| REFERENCE: | Nova Bus Manuals |
| RS N°: | MQR 7621-1960 |

| SUBJECT: | Charge air cooler (CAC) pipings |
| JUSTIFICATION: | Improved sealing of the joints of the charge air cooler piping. |

Figure 1 - CAC pipes Clamp Locations

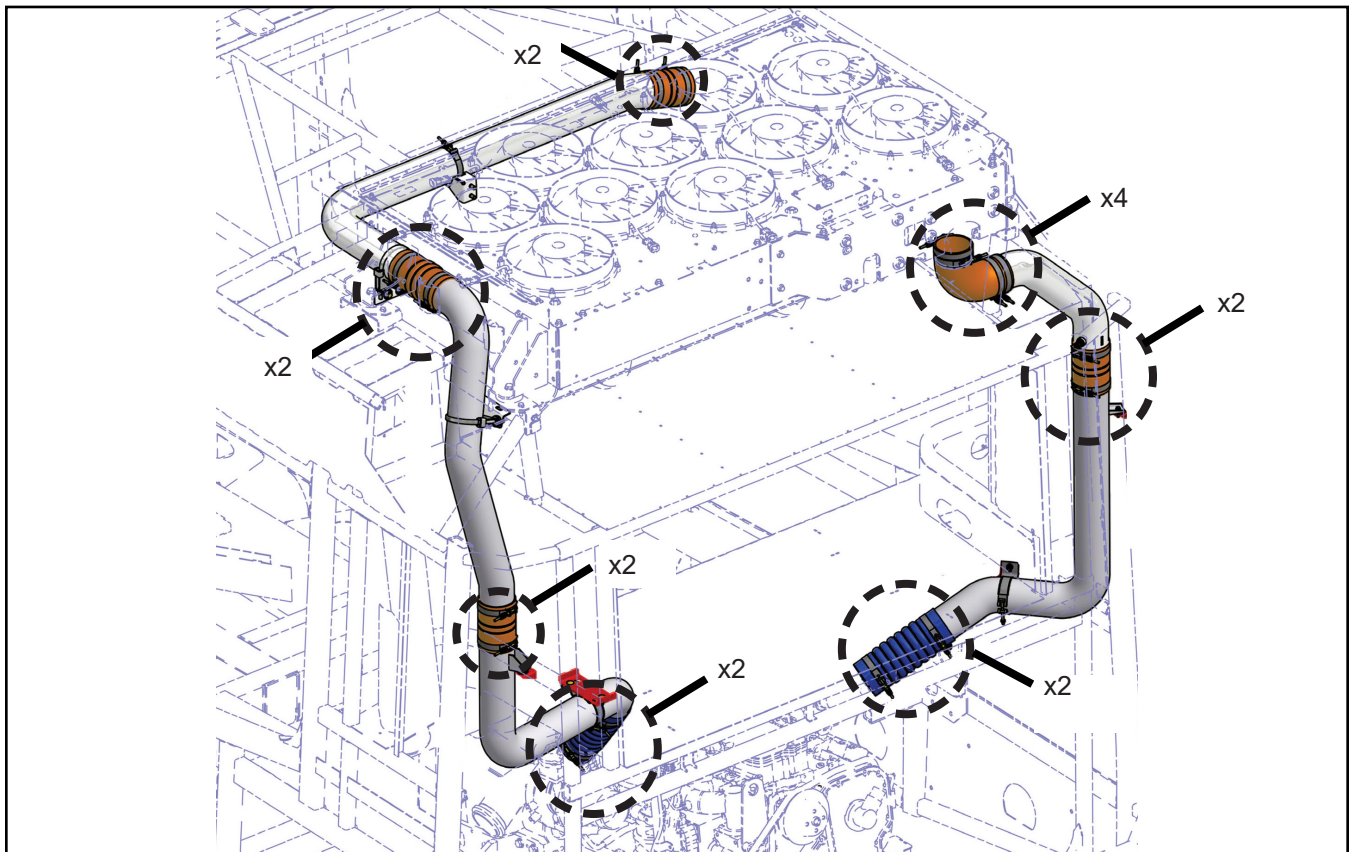
| LEVEL | DESCRIPTION | DIRECT CHARGES | | TIME |
|-------|--|----------------|----------|------|
| 1 | Replace the CAC clamps with the new constant-tension clamps. | Nova Bus | Nova Bus | 2h |

- 1.7. Orient the new clamp to facilitate maintenance and tighten it as close as possible to the raised bead. Apply a torque of $13.5 \pm 2 \text{ N}\cdot\text{m}$ ($10 \pm 1.5 \text{ lb}\cdot\text{ft}$).

- 1.8. Repeat for all clamps shown in Figure 1, for a total of 16 clamps.
- 1.9. Start the vehicle and let it run at fast-idle for 15 minutes.
- 1.10. Apply the tightening torque of $13.5 \pm 2 \text{ N}\cdot\text{m}$ ($10 \pm 1.5 \text{ lb}\cdot\text{ft}$) again.
